Work Order ID 98112

Item Name: Crosstube Fwd High

DRAWING NO. D212-664-141	TITLE XTUBE ASSY (205/212/412 HI FWD)	REV. D	DART AEROSPACE LTD ENGINEERING ORDER		D.E.O. NO. D212-664-141-D-1	SHEET NO. SHEET 1 OF 2	SCALE NTS
DRAWN	CHECKED	MFG. APPR.	APPROVED	DE APPR.			
DATE 11.04.07	DATE 11.04.11	DATE 11.04.12	DATE 11/04/12	DATE 11.04.12

ADD AN INSPECTION WINDOW TO UNDERSIDE OF CROSSTUBE.

**D212-664-141/-141B  
ASSEMBLY DETAIL**

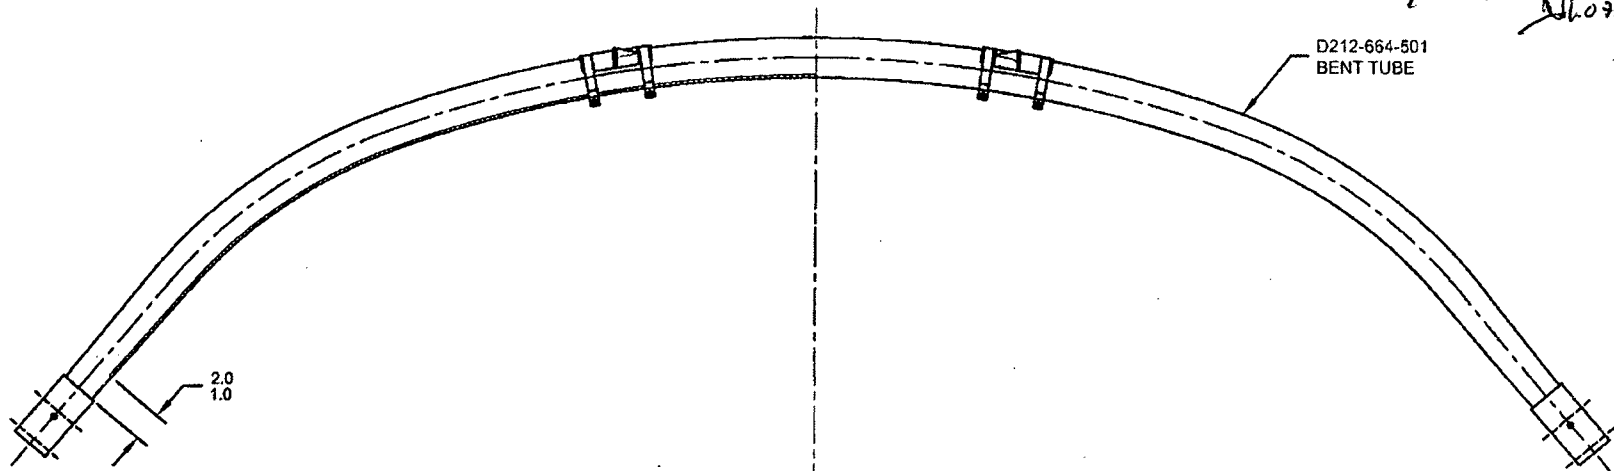
- 2) FINISH: CHEMICAL CONVERSION COAT PER DART QSI 005 4.1  
PRIME INSIDE AND OUTSIDE PER DART QSI 005 4.2  
MASK UNDERSIDE OF CROSSTUBE AS SHOWN (HATCHED AREA) AND  
PAINT OUTSIDE PER DART QSI 005 4.2  
REMOVE MASKING AND APPLY CLEAR COAT

MASK AREA PRIOR TO PAINTING,  
REMOVE MASKING AFTER PAINT  
AND APPLY CLEAR COAT
